Service Bulletin

1959

NO. 349

FIG. 1

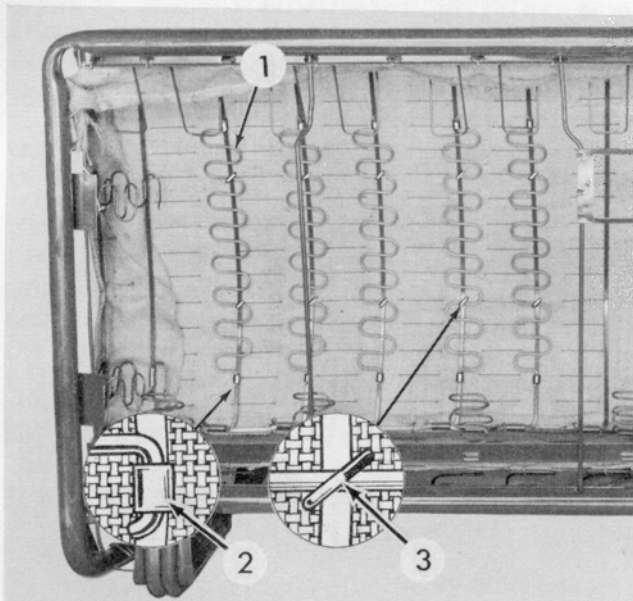
Some seat cushion and seat back sagging has occurred on 1959 cars; especially on taxicab and severe service vehicles. To correct this sagging condition a Front Seat Cushion or Back Heavy Duty Kit AC-2986 (Part No. 1333999) has been released for service. This kit consists of Reinforcing Elements, Part No. 13331396, Clips, Part No. 1333553, and instructions for installing the elements in the seat cushion and seat back. See Fig. 1

FIG. 2

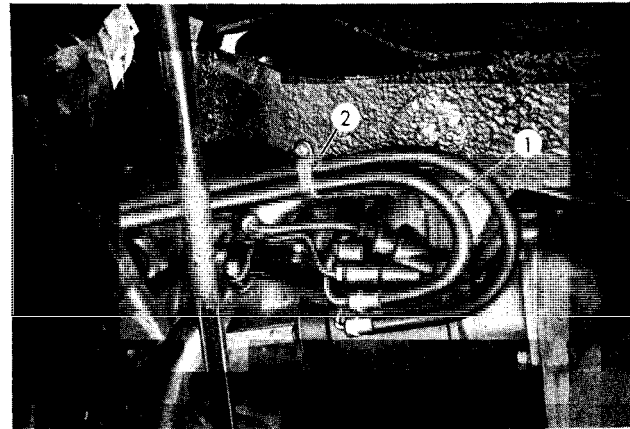
We have received reports of power steering hoses coming in contact with the exhaust manifold and steering gear. Investigation reveals that in most cases the hoses were improperly positioned, twisted and not properly secured.

Figure 2, an underneath view of the left-hand side of the car, illustrates the position of the power steering control valve-to-cylinder hoses and their retaining clamp. Note that the retaining clamp should be approximately at a right angle to the center line of the car, also that the hoses parallel one another as well as the frame.

FIG. 3

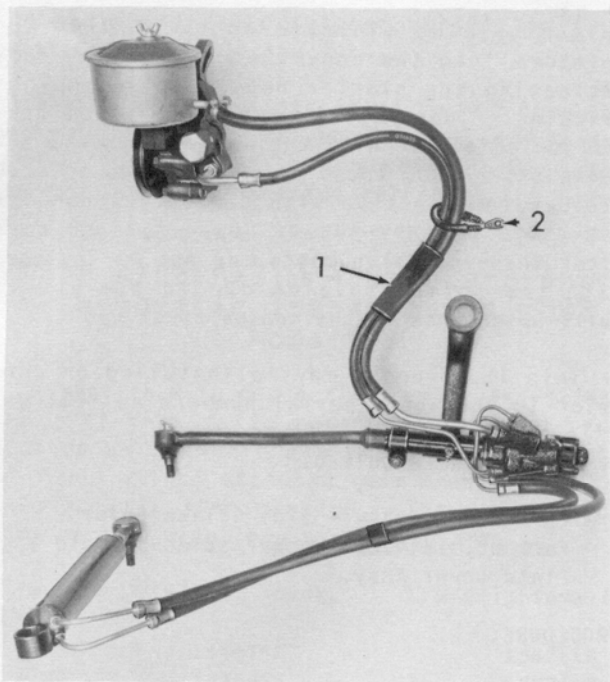
The relative position of the power steering pump, control valve assembly, pitman arm and reach rod, and the power steering cylinder are shown in Fig. 3. This illustration reproduces, as closely as possible, the relative positioning of these units and hose assemblies in their installed positions. The protective grommet on the power steering pump-to-control valve hoses should be located approximately 7" from the lower end of the hoses. This is necessary to prevent any scuffing of the hoses by the steering gear housing. The spring wire and sleeve assembly must be wrapped around the two pump-to-control valve hoses approximately 3" above the protective grommet, with both ends of the spring secured to the retainer clip

FIG. 4

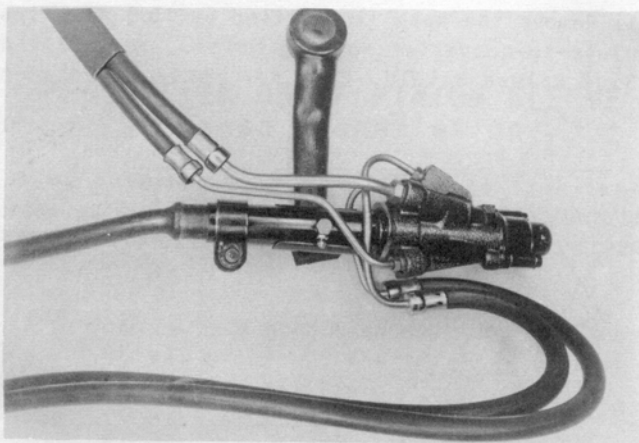
A close-up side view of the control valve assembly, (see Fig. 4), shows the correct positioning of the hose and tube assemblies. Note that the control valve-to-power steering cylinder hoses are parallel and should be secured by the frame clip (see Fig. 2) so that the hoses do not droop downward at the looped portion of the hoses.

FIG. 5

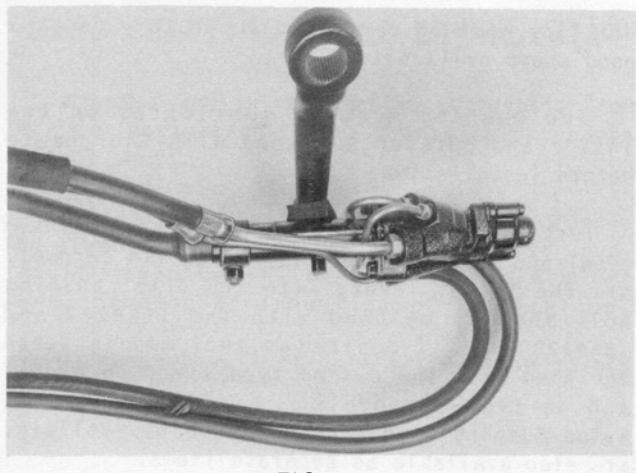
The top view shown in Fig. 5, illustrates the correct position of the power steering

FIG. 6

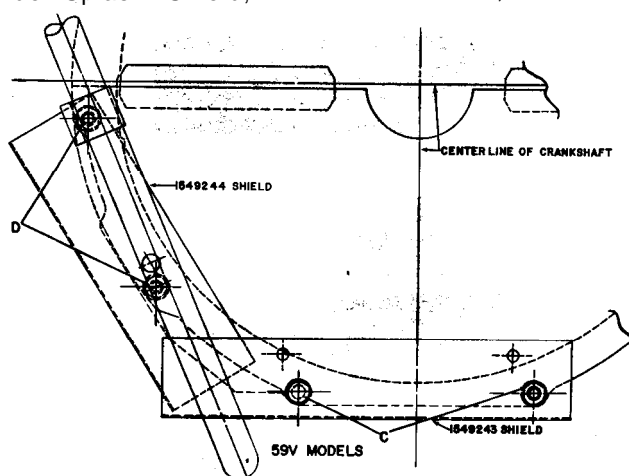
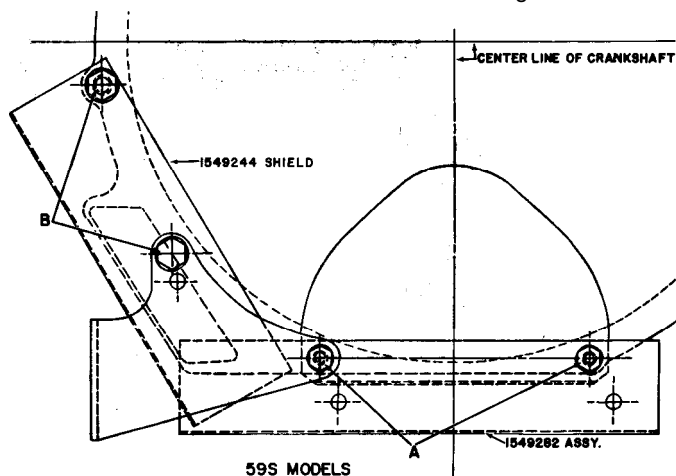
Two new splash shields have been added to cars equipped with an automatic transmission. The combination of the new, lower splash shield assembly and the new side splash shield protects the converter air cooling system opening in the housing and also the torque converter drain hole in the converter housing. These

1) Remove the two bottom engine rear plate-to-converter housing cap screws (identified by "A" in Fig. 6). Remove the engine rear plate cover and clip assembly and discard.

2) Remove the two engine rear plate-to-converter housing screws identified by "B" in Fig. 6. Install Part No. 1549244, Side Splash Shield, and reinstall the cap screws. This shield should be installed between the exhaust pipe support bracket and the engine rear plate.

3) Install the Lower Splash Shield and Plate Cover Assembly, Part No. 1549282 and secure with the cap screw identified by "A"

1) Remove the nuts (identified by "D") from the plate-to-converter housing bolts. Install the Side Splash Shield, Part No. 1549244, between

2) Remove the nuts identified by "C" from the bottom torque converter housing-to-plate bolts. Install the Lower Splash Shield, Part No. 1549243, on the bolts and reinstall the nuts.

FIG. 7

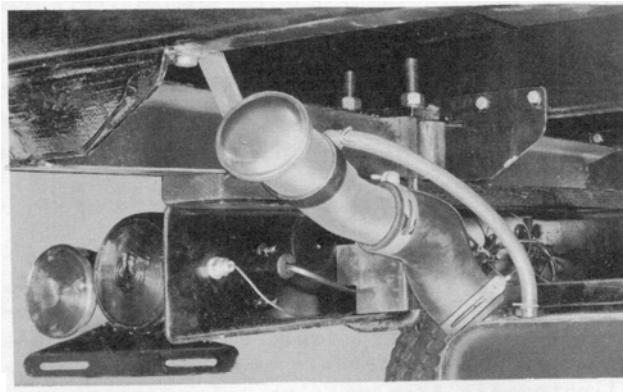
It has come to our attention that when a stake or platform body is installed on a 4-wheel drive truck after production some difficulty may be experienced in filling the gasoline tank.

This difficulty can be corrected by modifying the gasoline tank filler neck as shown in Fig. 7.

FIG. 8

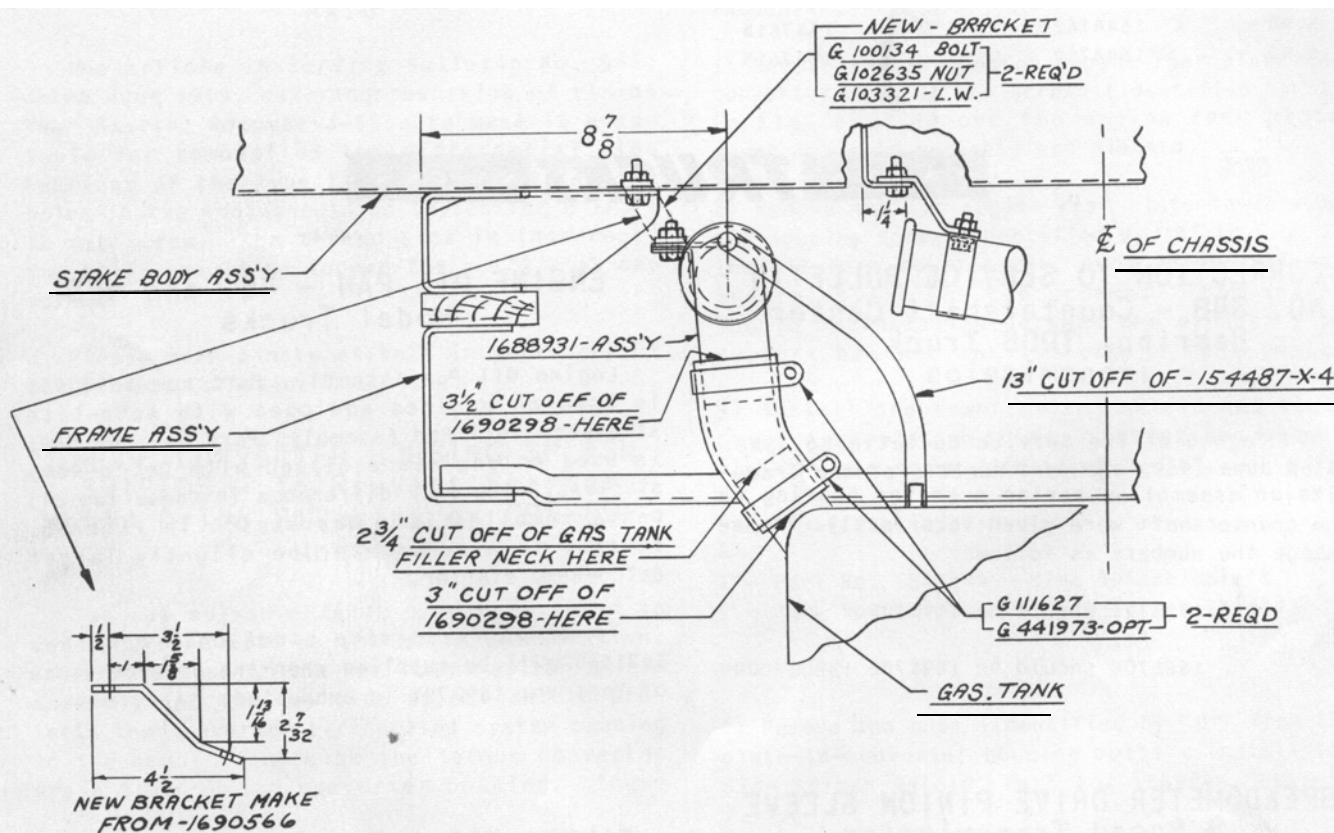
Complete details for the modification are shown in Fig. 8. All parts listed are available through your Parts Depot.
